APPLICATION NO.	FILING DATE	FIRST NAMED INVENTOR	ATTORNEY DOCKET NO.	CONFIRMATION NO.
10/719,863	11/19/2003	Bruce Reid Lee		1514

This is an office action for serial number 10/719,863, entitled Scuba Tank Mounting Brackets, in response to Amendments filed on March 9, 2005 and November 1, 2004.

FIG. 1

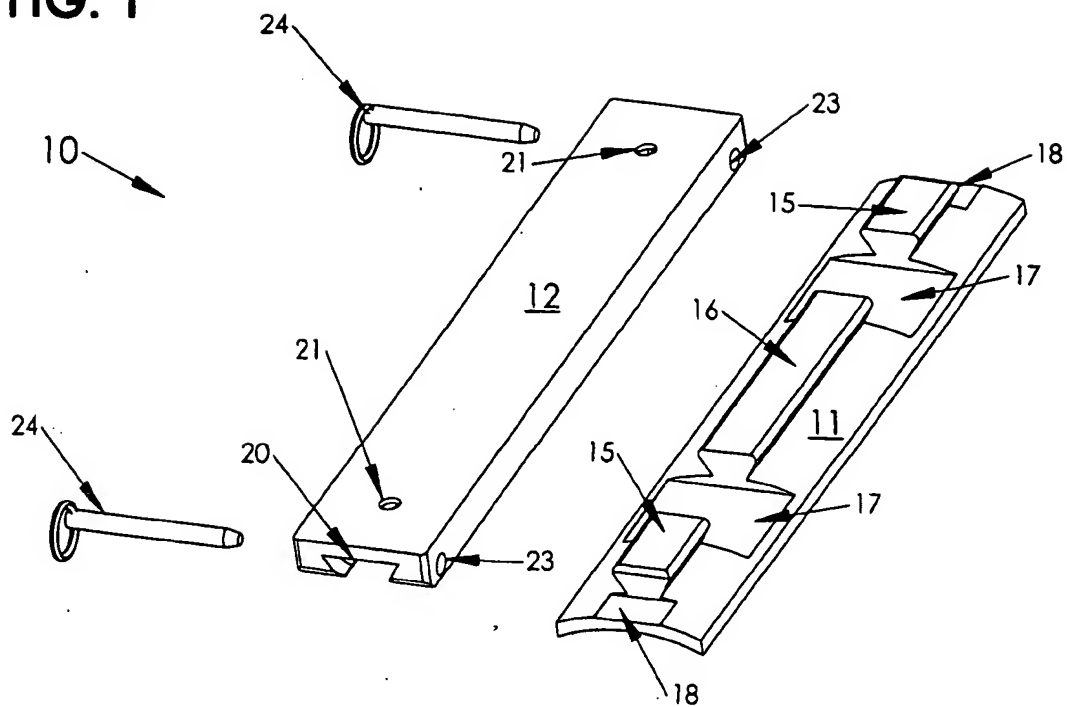
The substitute specification filed November 1, 2004 has not been entered because it does not conform to 37 CFR 1.125(b) and (c) because: It does not include a marked up copy of the substitute specification; it introduces new matter consisting of the slots (17) recessed below the face of the bracket and the nuts for screws.

The drawings were received on November 1, 2004. These drawings are disapproved.

disapproved kw 5/31/05

In addition to Replacement Sheets containing the corrected drawing figure(s), applicant is required to submit a marked-up copy of each Replacement Sheet including annotations indicating the changes made to the previous version. The marked-up copy must be clearly labeled as "Annotated Sheets" and must be presented in the amendment or remarks section that explains the change(s) to the drawings. See 37 CFR 1.121(d)(1). Failure to timely submit the proposed drawing and marked-up copy will result in the abandonment of the application. The Replacement Sheet must be clearly labeled as "Replacement Sheet".
